S E R V I C E N O T E

89430A RF Section

Sharp Metal Edge Shorting Power Supply Cable**To Be Performed By:** Agilent-Qualified Personnel**Duplicate Service Notes:** None**Parts Required:**

Figure 1

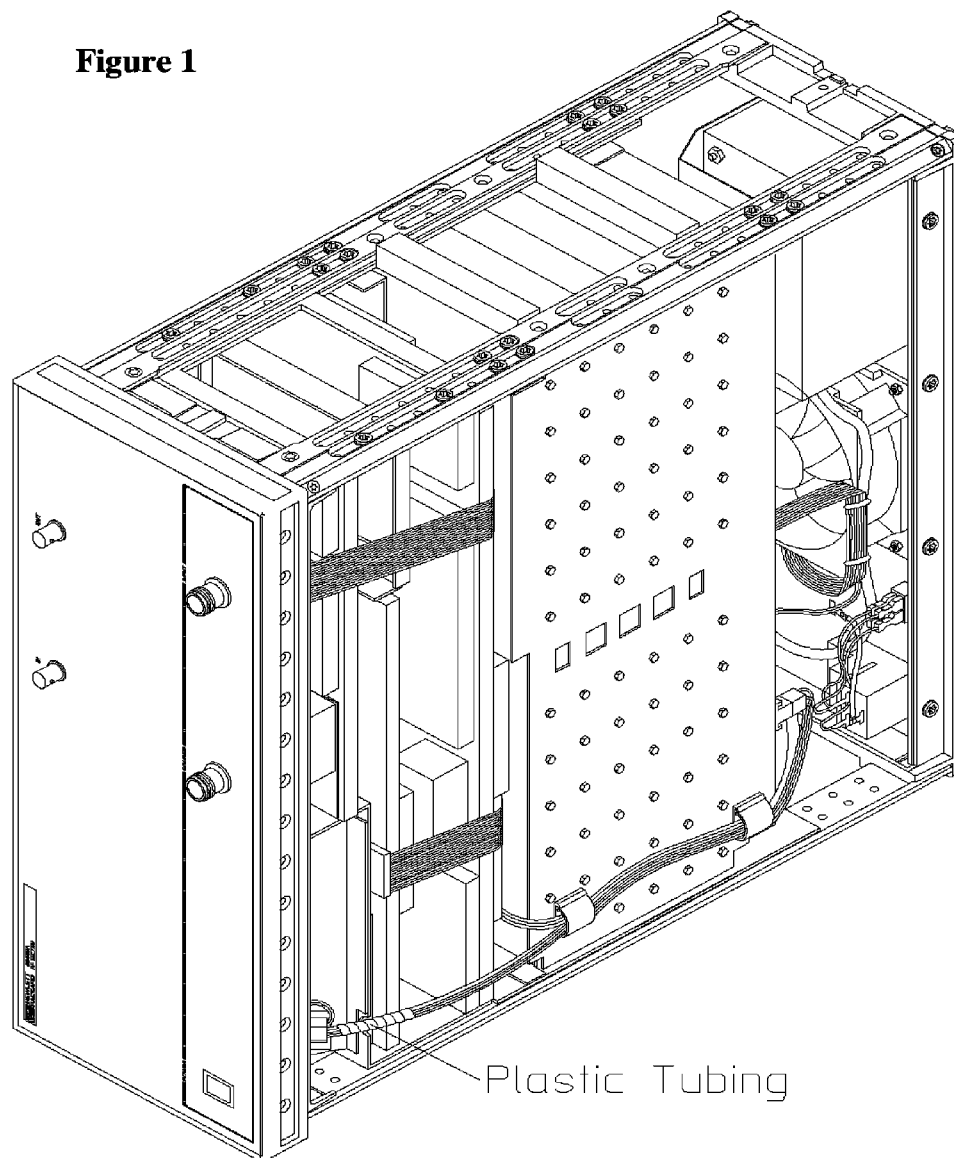
The insulation on a wire in a bundle of cables may be damaged by a sharp metal edge resulting in a power supply short.

STEP 2: Place the spiral plastic tubing over the bundle of cables which cross the A99 Motherboard and the sheet metal bracket MP111. See Figure 1.

Perform the following steps to place a plastic tubing over bundle of cables at the sharp metal edge location.
